**From:** Eccleston, Charles  
**Sent:** Thursday, August 12, 2010 5:49 PM  
**To:** Spangler, Nicole  
**Cc:** Rikhoff, Jeffrey; Imboden, Andy; Pham, Bo; Eccleston, Charles  
**Subject:** FW: Salem and Hope Creek Chapter 4 - Technical review of Land Use, Socioeconomics, and EJ Sections  
**Attachments:** Chapter 4 -V 1\_Part 2 - JJR edits 081210.docx

**From:** Rikhoff, Jeffrey  
**Sent:** Thursday, August 12, 2010 4:27 PM  
**To:** Eccleston, Charles  
**Cc:** Imboden, Andy; Pham, Bo  
**Subject:** RE: Salem and Hope Creek Chapter 4 - Technical review of Land Use, Socioeconomics, and EJ Sections

Attached is my redline/strikeout markup, corrections, and comments on Salem HCGS SEIS Chapter 4. I revised and corrected the land use, socioeconomics, and environmental justice sections. Overall, AECOM did a good job on these sections. Most of the revisions reflect updates to the discussions.

Figure 4-1. Census 2000 minority block groups within a 50-mi radius of Salem and HCGS

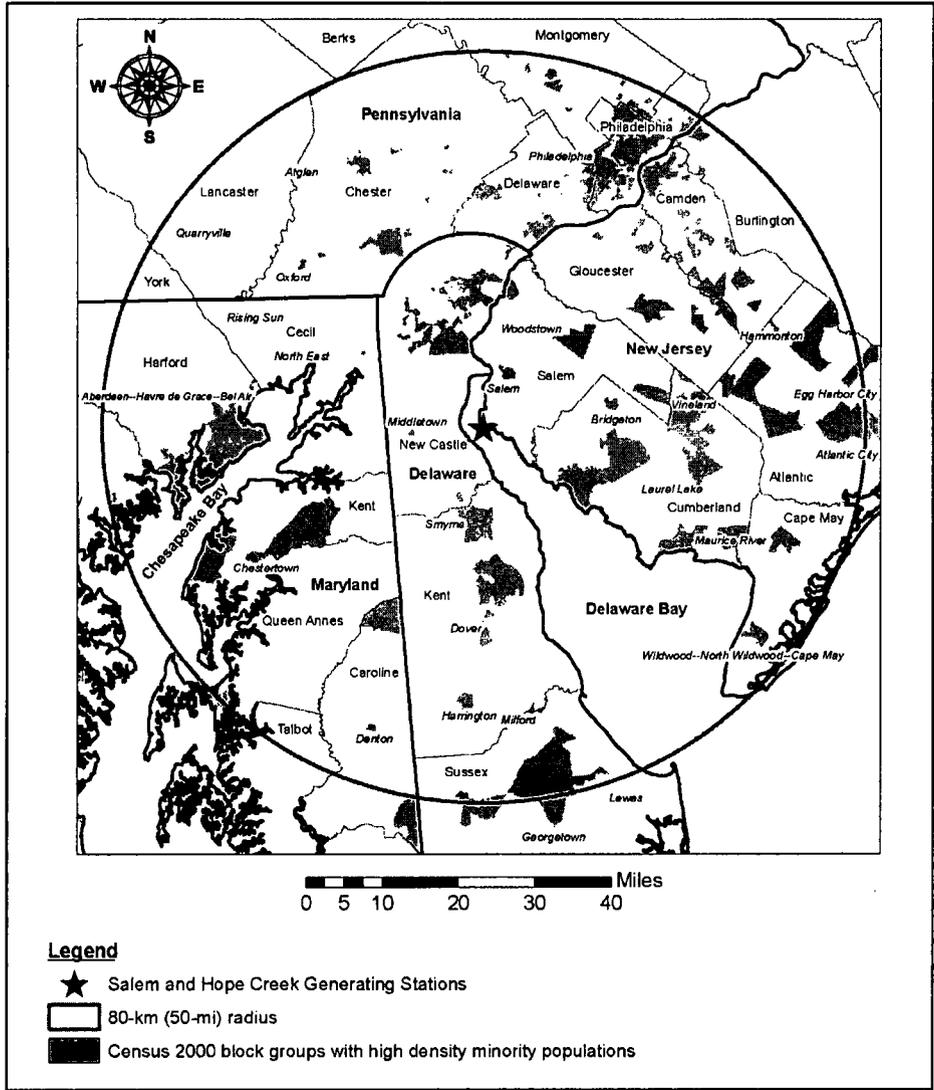
Comment [JJR3]: Delete the words "high density" in figure legend.

**Figure 4-2. Census 2000 low-income block groups within a 50-mi radius of Salem and HCGS**

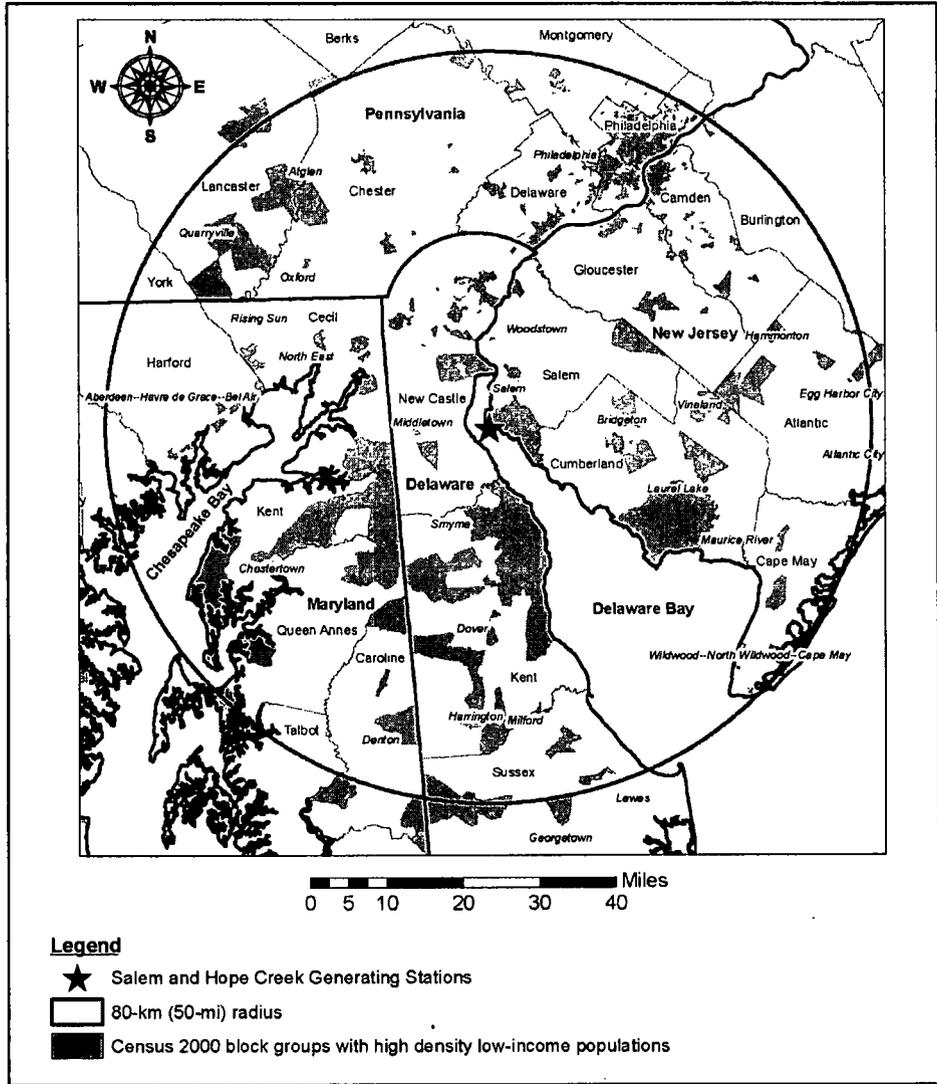
**Comment [JJR4]:** Delete the words "high density" in figure legend.
